# Sizewell C – Coastal morphology, climate change and the effectiveness of EDF’s Flood Risk and Shoreline Change assessments.

## May 2021

This paper is a response to EDF’s Sizewell C Flood Risk Assessment and approach to shoreline change and offshore geomorphology as presented in the Development Consent Order (DCO) application.

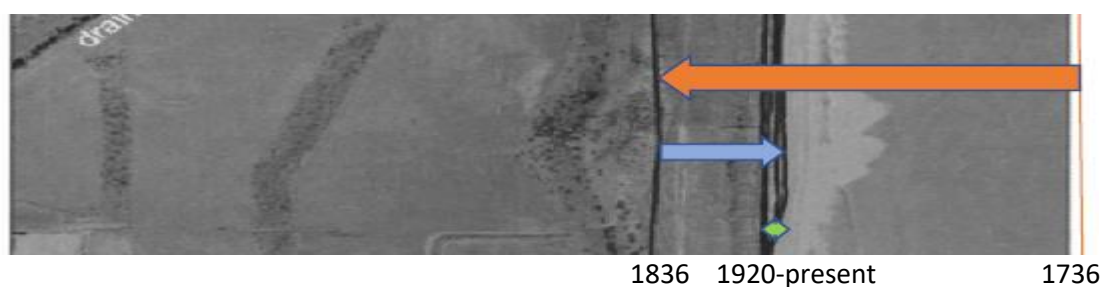
The figures in the table are sea level in metres AOD around the main nuclear platform. The red figures are marked by EDF as being significantly over the main platform height of 7.3m. RCP8.5, H++ and BECC are climate change scenarios explained in section 4. Note that BEEMS TR322 shows still water flooding of the main platform in 2090 at 1:10,000. See section 4.2.

- On inspection of the data in EDF’s table above, the wave overtopping component turns out to be a small fraction of the overall level (0.1-0.5m). This is presumably because wave overtopping is considered by EDF to be controlled by the raised height of the Hard Coastal Defence Feature design submitted in the FRA Addendum. See section 7.

**Plate 5.3: Representation of the main platform and HCDF in the inundation model**

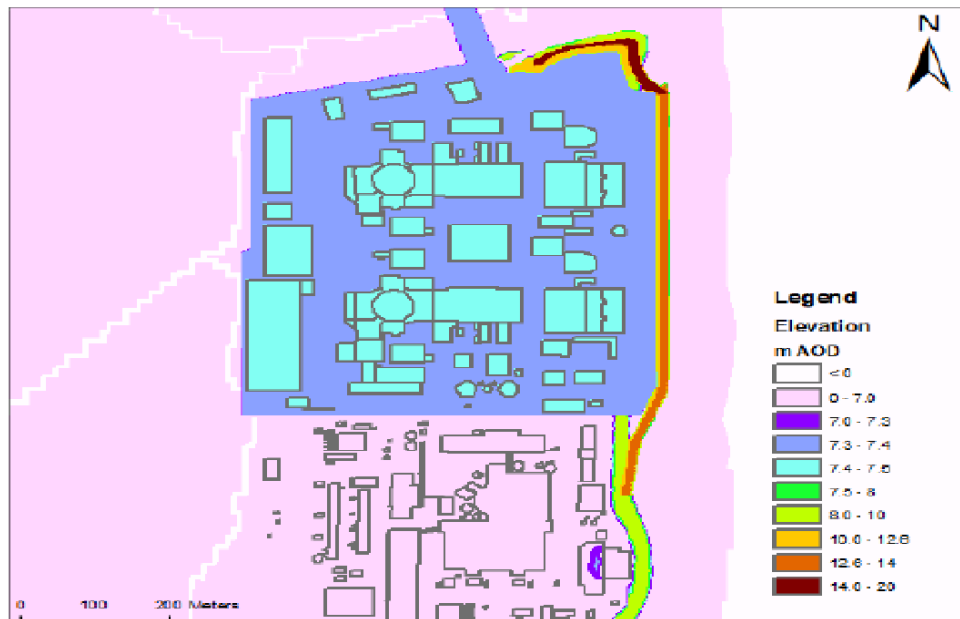
- However, the adjoining Sizewell B which has a 10m AOD sea defence crest height. The proposed sea defence designed for Sizewell C (14.6m - 16.4m AOD) does not appear to cover the frontage of Sizewell B (see Plate 5.3 below). **I have not seen an explanation for this. Sizewell B will not respond to correspondence asking whether they will increase sea defence height. In its present form, according to EDF in its statement above, Sizewell B’s defences must represent a danger to itself and Sizewell C by 2046.**

This does not appear to resolve the questions raised above relating to sea defence height disparity.

EDF Addendum: Main Development Site Flood Risk Assessment Addendum Appendices A-F Part 10 of 10. Note in Plate 5.3 that the 12.6m-14.6m sea defence contour of Sizewell C merges into the mainly unchanged 8-10m Sizewell B defences

**Plate 4.3: Proposed Permanent HCDF cross-sectional profile (extract from EDF Energy drawing no. SZC-EW0601-XX-000-DRW-400025 rev. 01, 27/11/20)**

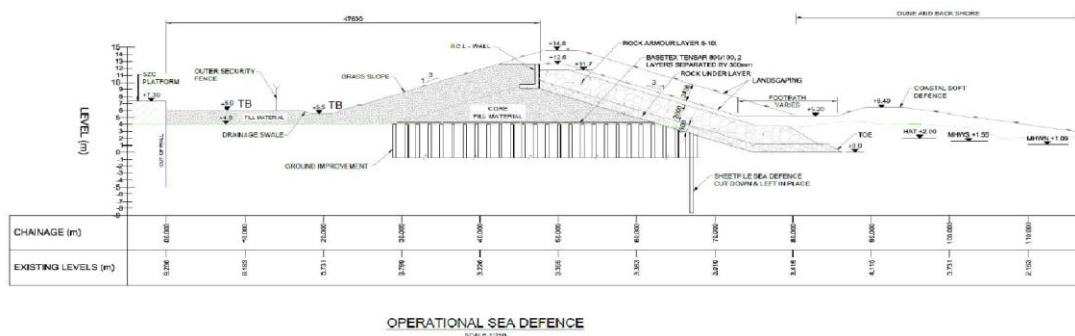
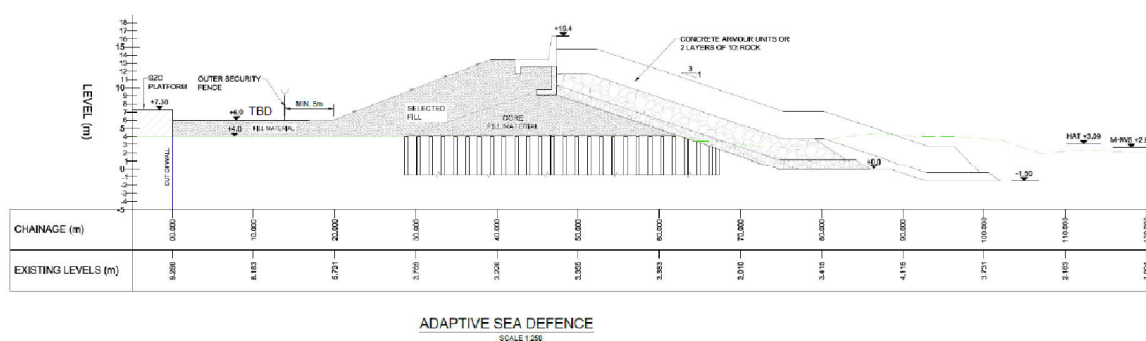
The FRA Addendum of January 2021—in order to achieve a more “conservative tolerable overtopping rate”—changed this to become **12.6m** AOD (with landscaping to **14.6m** AOD) and adaptive change to **16.4m** AOD (with landscaping to **18m** AOD). See section 7.

EDF states in its FRA Addendum that the ‘adaptive’ raised crest height of 14.2m—suggested as a ‘potentiality’ in the original FRA would, in fact, have been required by 2046 – little more than a decade after plant completion. EDF also affirms that it was aware of this requirement at the time, however:

- The newly proposed Addendum Hard Coastal Defence Feature, landscaped to 14.6m, reduces to 10m as it meets the adjoining defences for Sizewell B—presumably a risk to both Sizewell B and Sizewell C stations by 2046 according to EDF’s statement above. Sizewell B will not reply to my correspondence. See section 7 and 10.
